Date of Issue: November 2010

Affected Publication: API Recommended Practice 1109, *Marking Liquid Petroleum Pipeline Facilities*, Fourth Edition, October 2010

ERRATA

This errata corrects editorial errors in the fourth edition of API Recommended Practice 1109.

Figure 2—Examples of Cross Country Markers and Signs

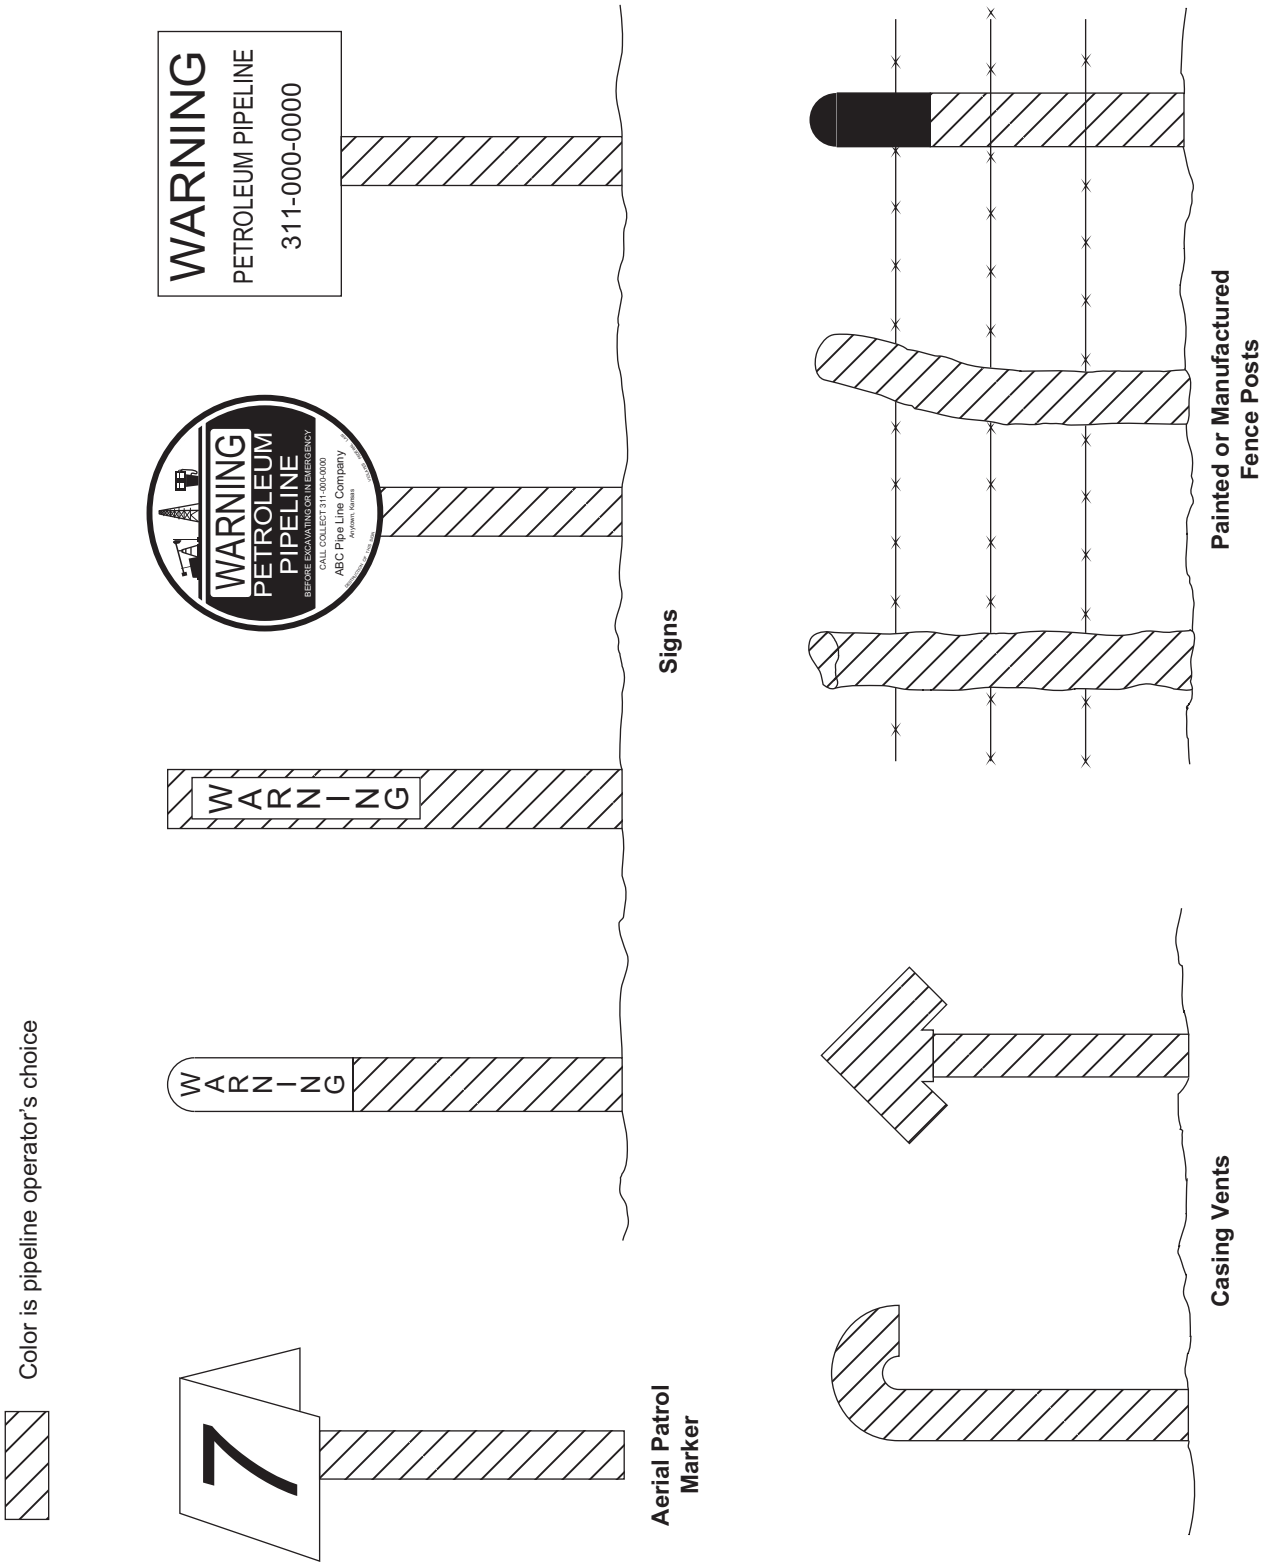
Page 5, Figure 2, (in the lower left) it should read:

rather than

“Casting Vents”

“Casing Vents”
